Questions

Aera is exploring the option of repurposing existing 64 Zone oil/gas producers as Class VI injection wells.

Well Construction Example

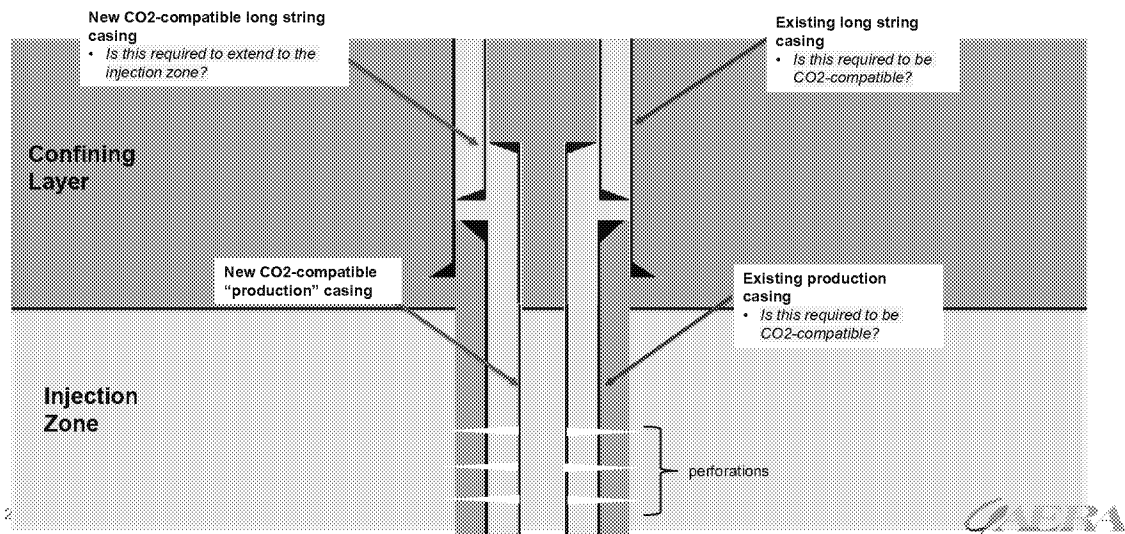
- Does EPA have any concerns with repermitting oil/gas production wells from the early-to-mid 1900's as Class VI wells, provided they can be designed to meet the general requirements of CFR 146.86 (prevent movement of fluids, permit testing & monitoring)?
- CFR 146.86 also describes casing and cementing requirements. In the case of re-permitted wells, to what extent do these requirements apply to the original wellbore?
 - *Compatibility*: If a CO2-compatible casing string were cemented within an existing wellbore, must the original well's casing also be constructed with CO2-compatible materials?
 - *Casing Depth*: In many cases, the long string casing in existing wells only extends into the confining layer, just above the injection zone, and prevents a new long string casing from reaching the injection zone. Must the new long string casing extend to the injection zone?

See diagram on next slide
